TRANS/WP.29/GRSP/2003/16
24 September 2003

World Forum for Harmonization of Vehicle Regulations (WP.29)

PROPOSAL FOR DRAFT AMENDMENTS TO REGULATION No. 16
(Safety-belts)

Transmitted by the expert from France

"Annex 8

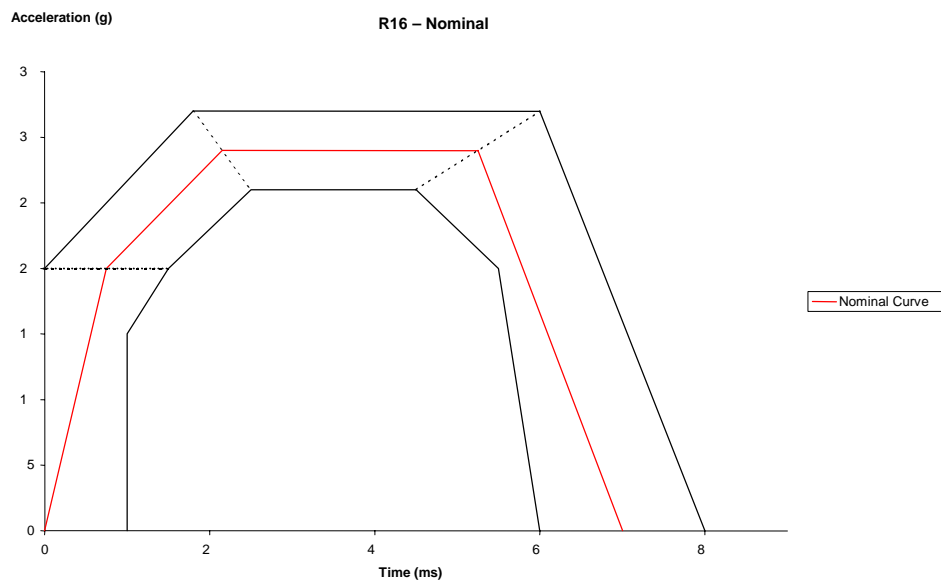
The trolley shall be so propelled that, during the test, its speed variation is $[56 \text{ km/h} \pm 4 \text{ km/h}]$ and its acceleration curve is within the hatched area of the graph in annex 8. The trolley shall remain horizontal during the acceleration. In inert mass, the acceleration curve shall be centred in the hatched area of the graph in annex 8 and the speed variation will be $[56 \text{ km/h} \pm 2 \text{ km/h}]$. Despite the fulfilment of the above requirements, the technical service can use a mass of trolley (equipped with its seat), as specified in paragraph 1 of annex 6, superior to 380 kg ."

Annex 8, amend to read:

DESCRIPTION OF CURVE OF TROLLEY' S DECELERATION (ACCELERATION)
AS FUNCTION OF TIME

Parts of annex 8 have been put in paragraph 7.7.4. in order to use the same annex 8 for the two test devices (acceleration and deceleration).

As it can be seen in the table below the actual pulse corridor permits a wide range of variation of speed if there is no defined impact speed.

It is for that reason that a variation of speed of 56 km/h has been defined for the acceleration test device. This variation of speed corresponds to nominal curve and also to actual variation of speed on deceleration test devices including impact speed plus rebound speed.
